Work Order ID 101949

Item Name: Crosstube Fwd High

DART AEROSPACE LTD		Work Order:	101949
Description: Crosstube High Fwd (205/212/412)		Part Number:	D212-664-101
Inspection Dwg: D212-664-141 Rev: D		Page 1 of 1

DRAWING NO. D212-664-141	TITLE XTUBE ASSY (205/212/412 HI FWD)	REV. D	DART AEROSPACE LTD ENGINEERING ORDER		D.E.O. NO. D212-664-141-D-1	SHEET NO. SHEET 1 OF 2	SCALE NTS
DRAWN	CHECKED	MFG. APPR.	APPROVED	DE APPR.			
DATE 11.04.07	DATE 11.07.11	DATE 11.04.12	DATE 11/04/12	DATE 11.04.12

D212-664-141/-141B
ASSEMBLY DETAIL

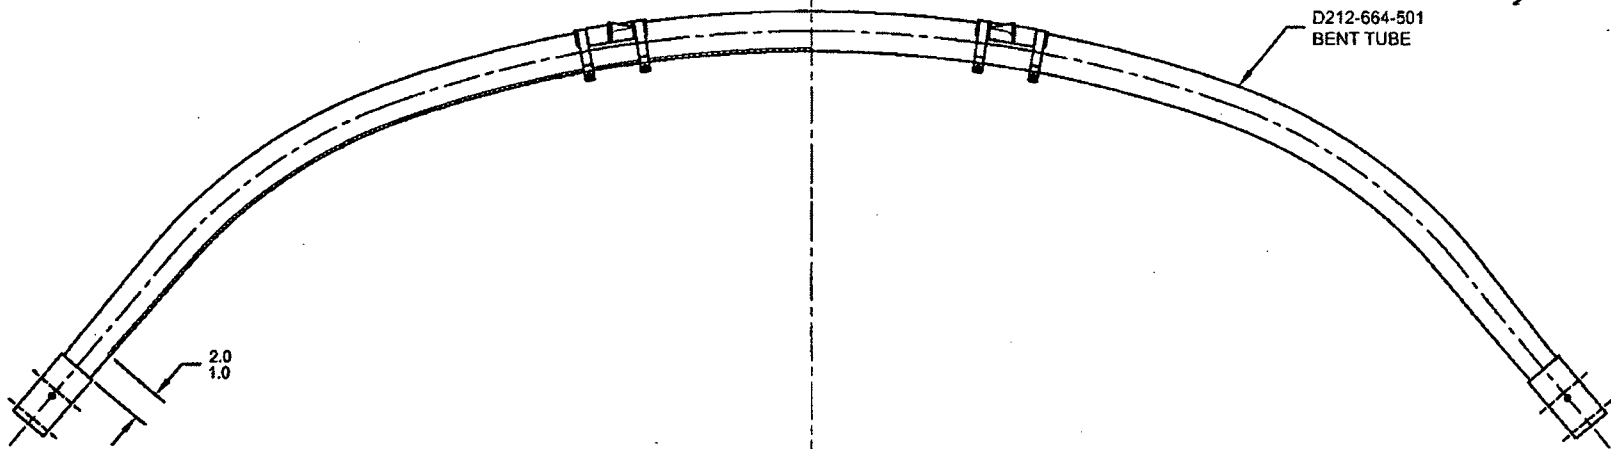
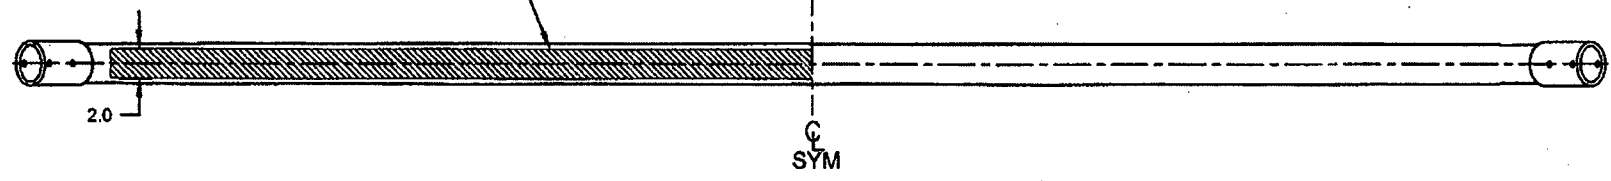
ADD AN INSPECTION WINDOW TO UNDERSIDE OF CROSSTUBE.

NOTES 2 OF SHEET 1 IS AMENDED AS FOLLOWS:

- 2) FINISH: CHEMICAL CONVERSION COAT PER DART QSI 005 4.1
PRIME INSIDE AND OUTSIDE PER DART QSI 005 4.2
MASK UNDERSIDE OF CROSSTUBE AS SHOWN (HATCHED AREA) AND
PAINT OUTSIDE PER DART QSI 005 4.2
REMOVE MASKING AND APPLY CLEAR COAT

MASK AREA PRIOR TO PAINTING.
REMOVE MASKING AFTER PAINT
AND APPLY CLEAR COAT
